REVISIONS AND ERRATA LIST

AISC Steel Design Guide 7, 2nd Edition

May 31, 2016

The following list represents corrections to the first printing (dated March 2005) of the second edition of AISC Design Guide 7, *Industrial Buildings—Roofs to Anchor Rods*.

Fig. 20.3.4 Critical Moment Diagrams

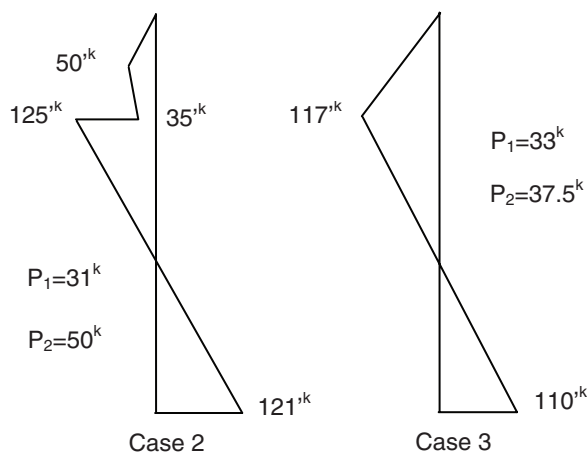
77	Figure 20.3.4 should be revised as shown:

Fig. 20.3.7 Critical Moment Diagram

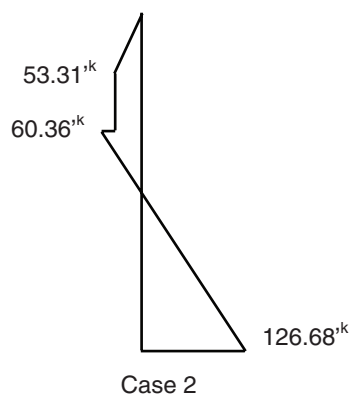
Figure 20.3.7 should be revised as shown:
